## Proposal for amendments regarding GRVA-12-52

Modifications to the existing text of UN-Regulation No. 157 are in **bold** for new or ~~strikethrough~~ for deleted characters.

UK modifications to GRVA-12-52 are in **blue bold** for new or ~~blue-strikethrough~~ for deleted characters.

#### Model B

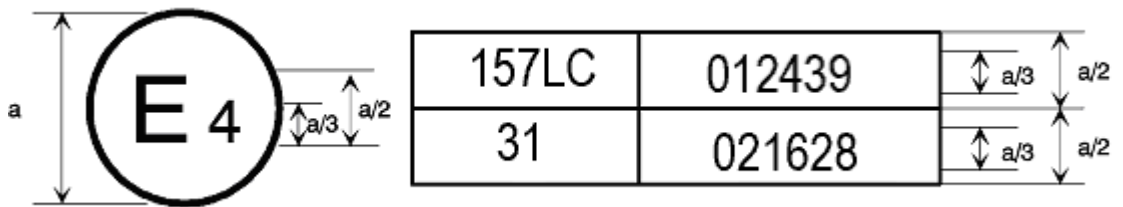
The above approval mark affixed to a vehicle shows that the vehicle type concerned has been approved in the Netherlands (E 4) pursuant to Regulations Nos. 157 (**capable of a lane change procedure**) and 31.<sup>1</sup> The approval numbers indicate that, at the dates when the respective approvals were given, UN Regulation No. 157 ~~was in its original version~~ **included the 01 series of amendments** and UN Regulation No. 31 included the 02 series of amendments.
